#### GENOA CHARTER TOWNSHIP PLANNING COMMISSION PUBLIC HEARING NOVEMBER 12, 2024 TUESDAY 6:30 P.M. AGENDA

Attention:	Amy Ruthig, Planning Director
Subject:	Proposed rezoning from PRF to SR (Review #2)
Location:	410 S. Hughes Road – west side of S. Hughes Road, south of Golf Club Road
Zoning:	PRF Public and Recreational Facilities District

Attention:	Amy Ruthig, Planning Director
Subject:	Misty Meadow Drive Phase 2 – Private Road Review #2
Location:	West side of S. Latson Road, south of Crooked Lake Road
Zoning:	RR Rural Residential District

#### Re: Misty Meadow Drive Site Plan Review No. 2

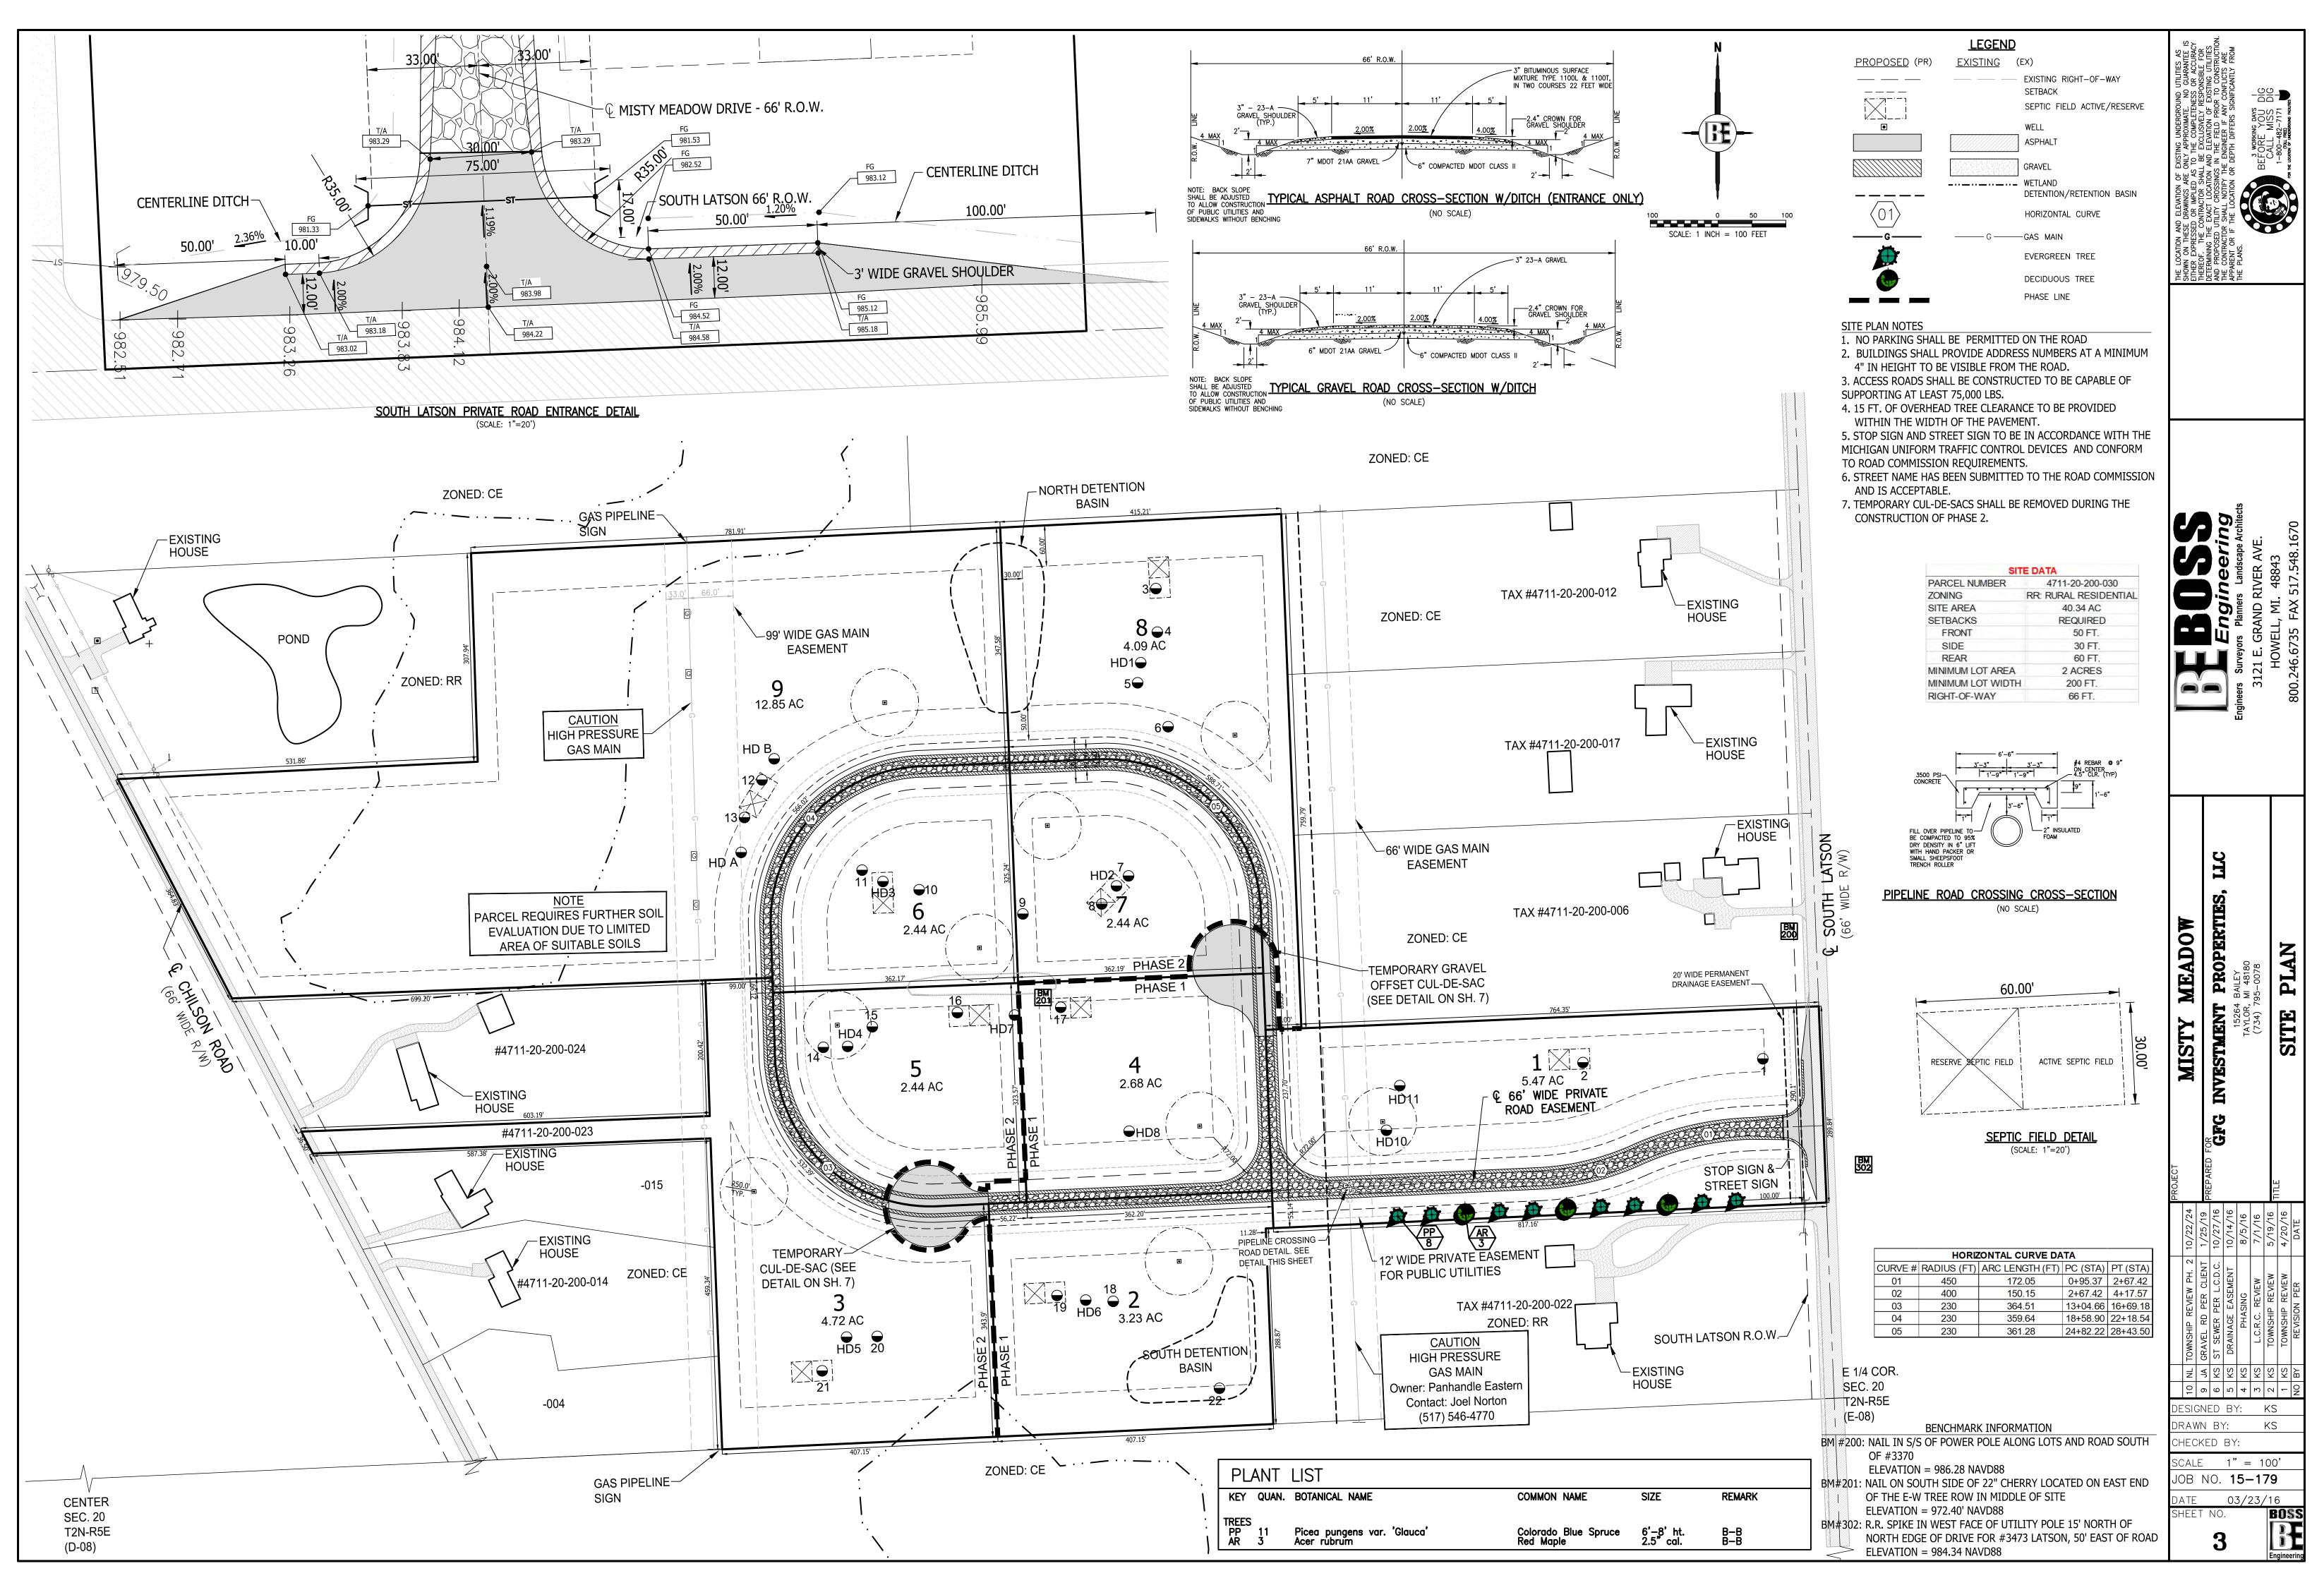
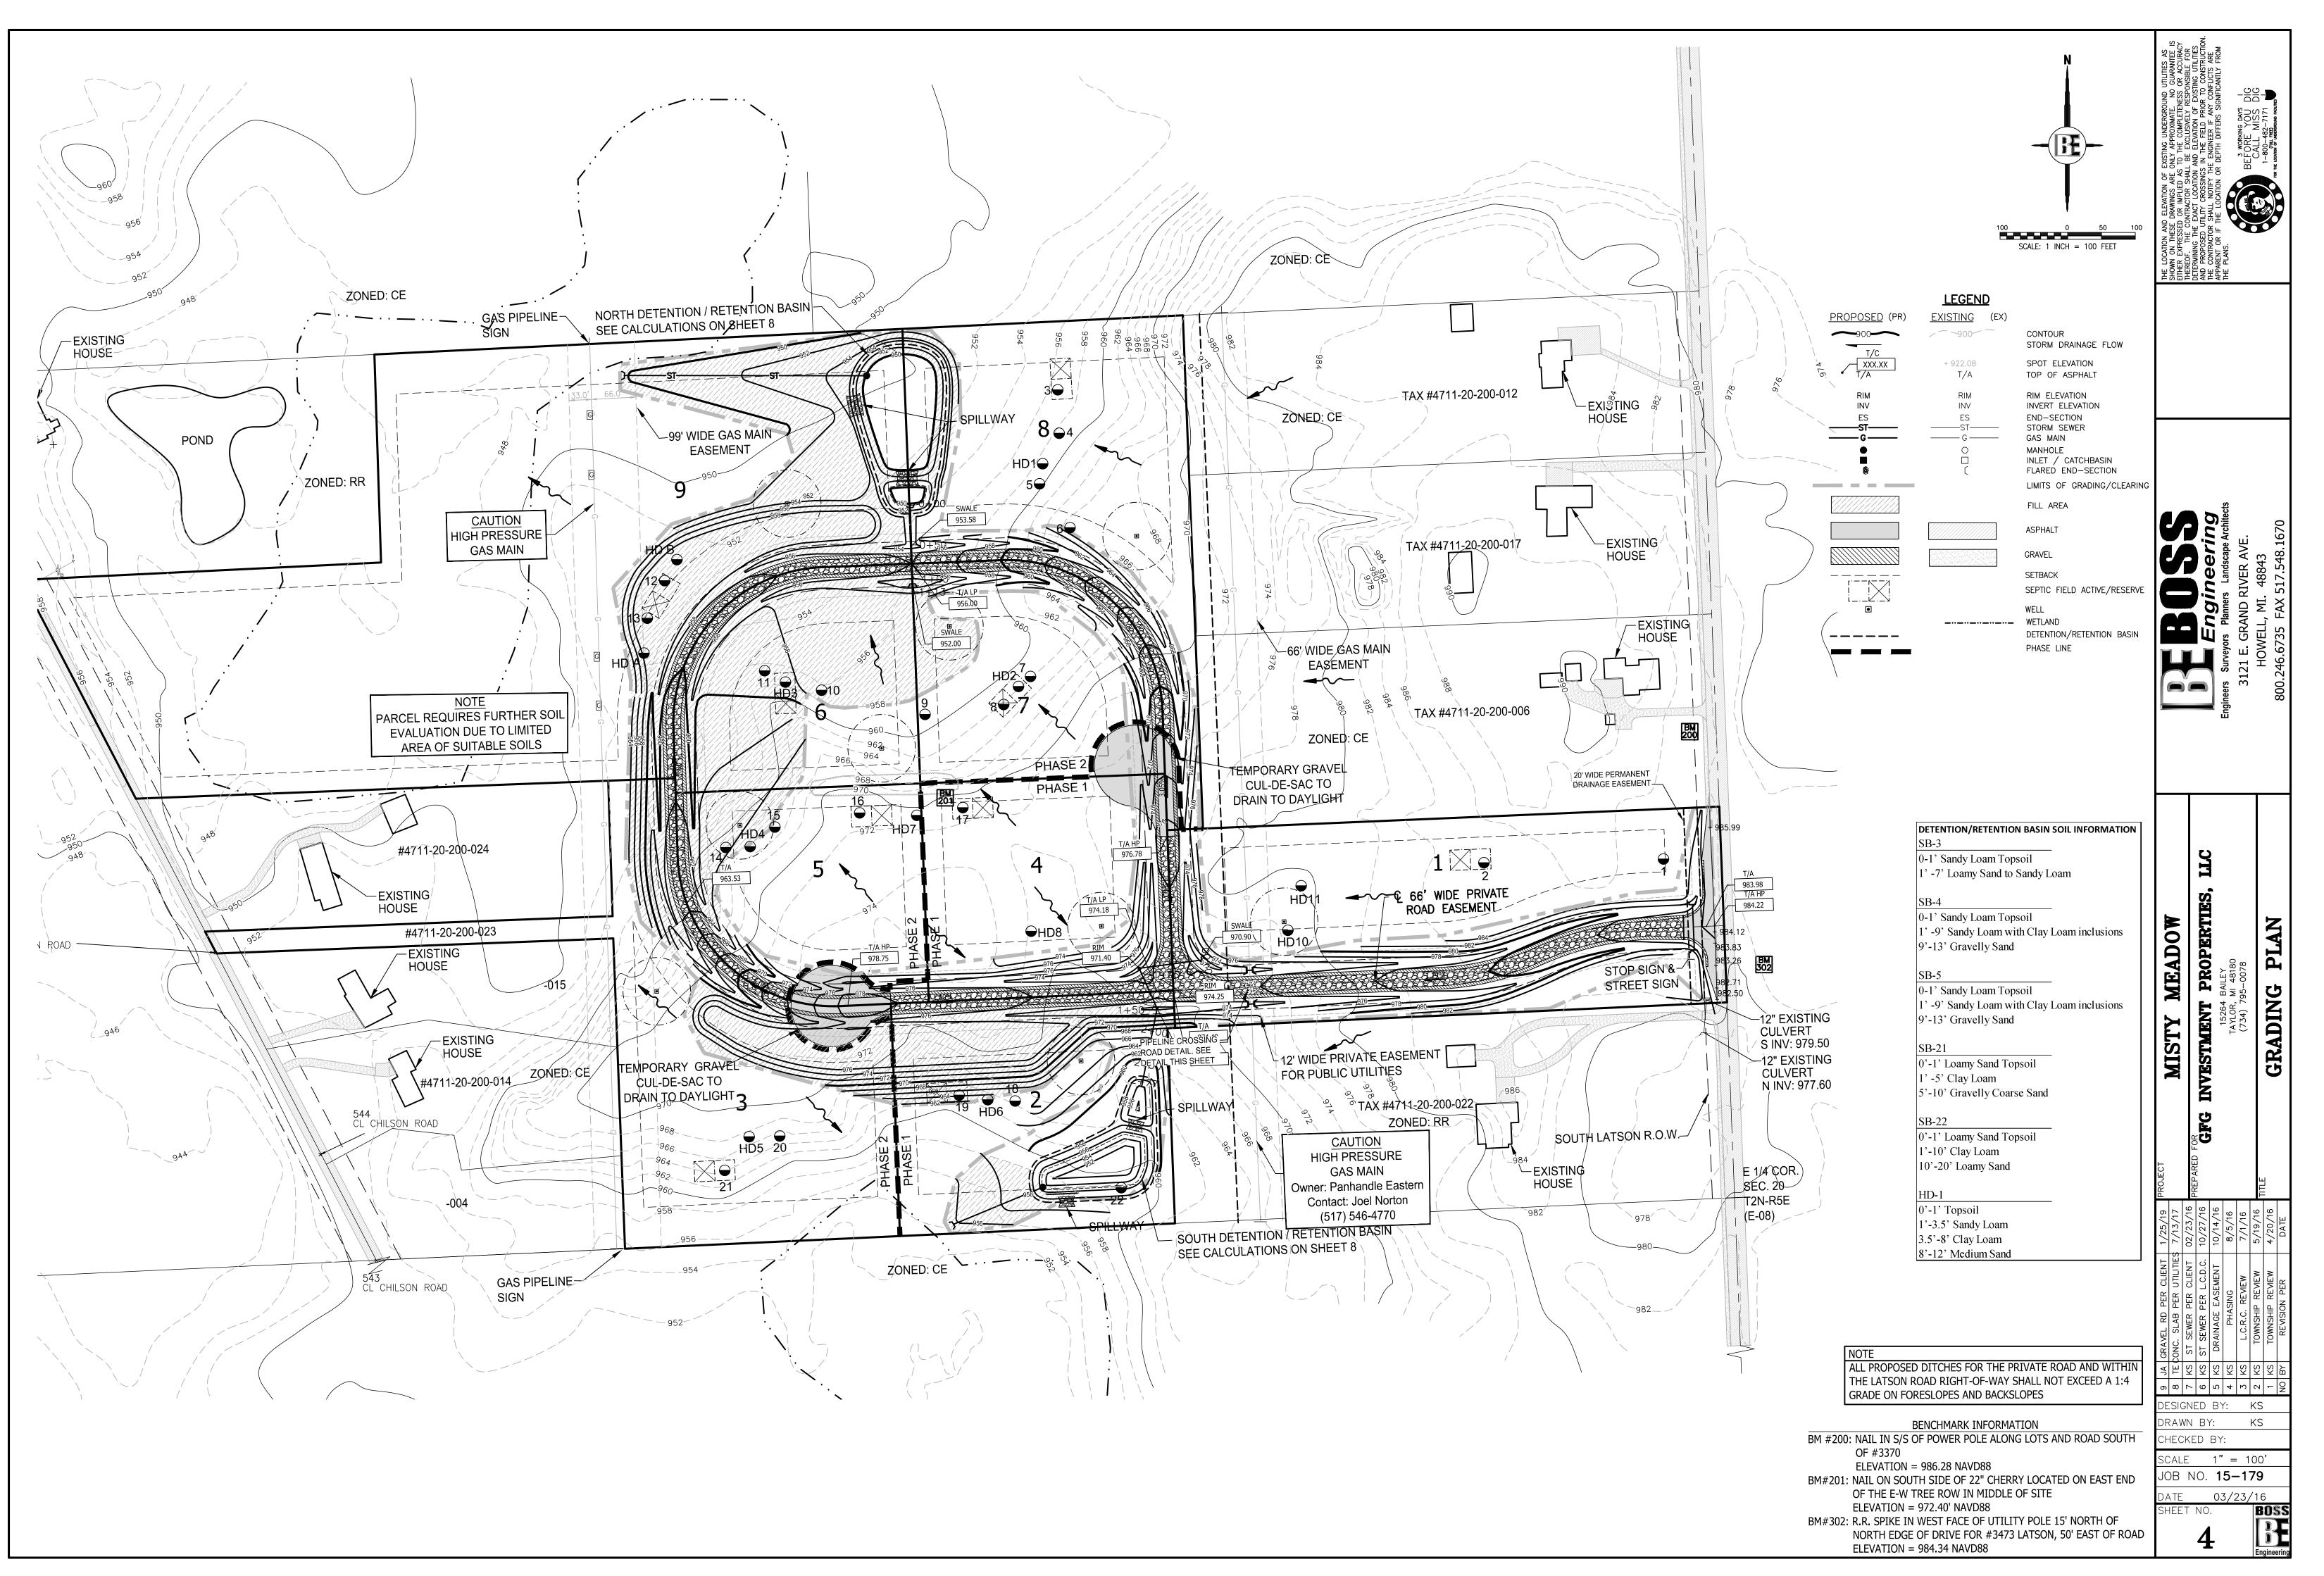
The typical cross-section depicted on Sheet 3 provides a 22-foot wide gravel roadway without curb and gutter, per Ordinance requirements.

- **11. Vertical Clearance.** Note #4 on Sheet 3 states that the required overhead tree clearance of 15 feet will be provided within the width of the pavement.

- **13. Signs.** Note #5 on Sheet 3 states that required stop and street signs will be provided in accordance with the requirements of the Michigan Manual of Uniform Traffic Control Devices and Road Commission.
- 14. Yard Setback. Phase 2 of the private road does not abut any of the surrounding property lines.
- **15. Impact Assessment.** The initial submittal included the previously approved Impact Assessment from 2016.
